Subject: PUBLIC COMMENTS RE: Edwards Aquifer Permit **13001906**

This letter constitutes my Public Comments and Public Meeting Request regarding the Vulcan Construction Materials, LLC Water Pollution Abatement Plan (WPAP) Application in Comal County, Texas (EA Permit No. **13001906**). The subject application is for a new 1,515-acre limestone quarry located between Bulverde and New Braunfels, Texas. It lies totally within the Edwards Aquifer Recharge Zone (Plate 1).

Figure 1. Stratigraphic cross-section (Source: J.M. Olivier after E. Kastning).

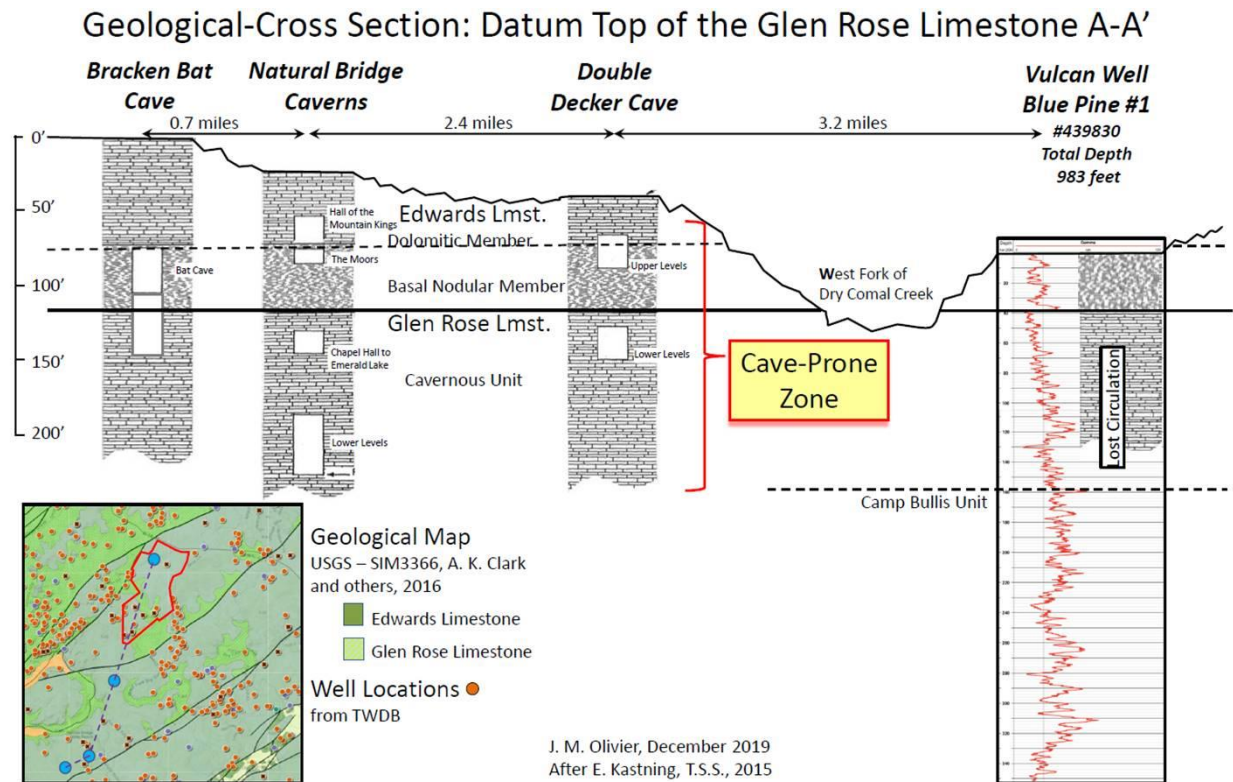
Stratigraphic cross-section A-A' (Figure 1 and Plate 1) shows the chambers at Natural Bridge Caverns, Bracken Cave, and Double Decker Cave. On the northern end of the cross-section, a water well drilled on the Vulcan Site lost circulation in a highly permeable interval while being drilled from a depth of 63 – 143 ft. This interval correlates to the Cave-Prone Zone, indicating the potential that significant caves may exist under the Vulcan Site. It also shows the high probability that the entire area is hydrologically connected with both the Edwards and Trinity Aquifers (Gary, et al., 2011).

Limestone. During drilling, the well encountered a highly porous and permeable zone (63–143 ft) in the Glen Rose Formation. This 80-ft interval corresponds to the Cave-Prone Zone seen in the caves to the south (Figure 1). As mentioned previously, this lost circulation zone is a strong indication that quarrying at the Vulcan Site could encounter large caves that are hydrologically connected to Edwards and Trinity Aquifers.

Figure 2. Diesel Spill in New Braunfels, TX (Source: G. Schindel, 2019)

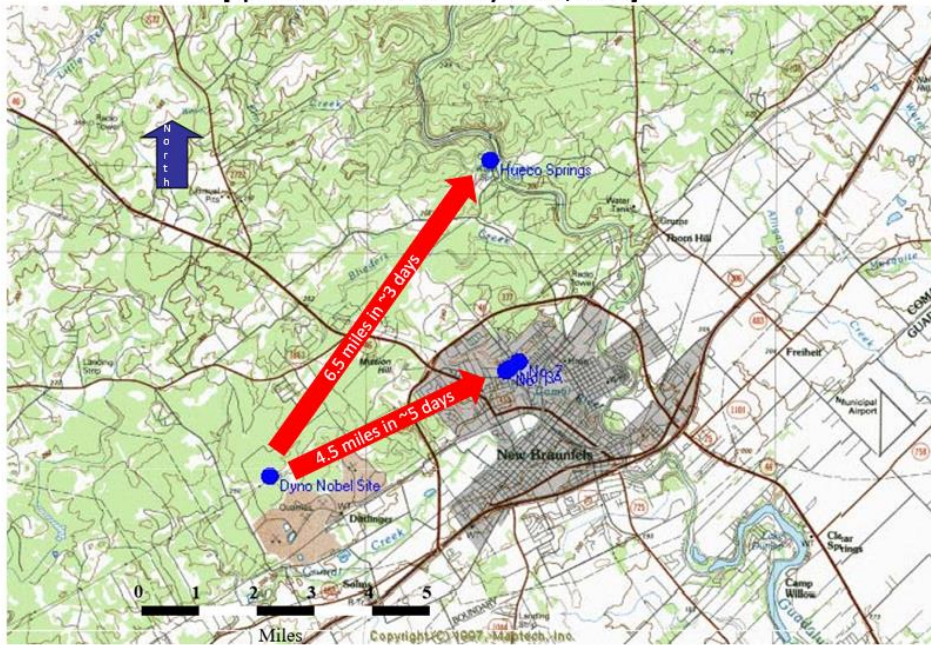
A diesel spill in January 2000 provided valuable groundwater flowpath information (San Antonio ExpressNews, 1/21/2000, Officials hopeful diesel spill in recharge zone contained). The spill occurred at the Dyno Noble explosives plant that was located in the EARZ near the city of New Braunfels (Figure 2). On or about January 17, two-thousand gallons of diesel fuel leaked into the ground from an approved, above-ground-storage tank (Dames & Moore, 2000, Hydrogeology of Dyno Nobel ANFO Manufacturing Facility, Comal Co., TX). Diesel was detected 3 to 4 days later at the Comal Springs and Hueco Springs, a distance of 4.5 miles and 6.5 miles, respectively (G. Schindel, CCCA presentation, 2019). Although the diesel concentrations detected at the springs were minimal, the leak confirmed two important points: 1) the groundwater flow rate in the EARZ is very rapid – well in excess of 1-mile per day, and 2) observable karst landforms are not necessary for groundwater contamination to occur.

A dye trace study is needed around the Vulcan Site to precisely determine the groundwater flowpaths. There are numerous domestic water wells along FM 3009 and points farther east that potentially would be at risk of contamination with nitrate and other hazardous substances if quarry operations are permitted. Nearby wells could experience nitrate levels above the EPA's maximum concentration limit safe for human consumption of 10 mg/L (N). Some of this water with elevated nitrate could make its way to Hueco and Comal Springs (Smith, 2024). Several protected, aquatic, endangered species live in Comal Springs. New Braunfels is heavily dependent on its water-based tourist industry that requires clean and plentiful groundwater from the Edwards Aquifer.
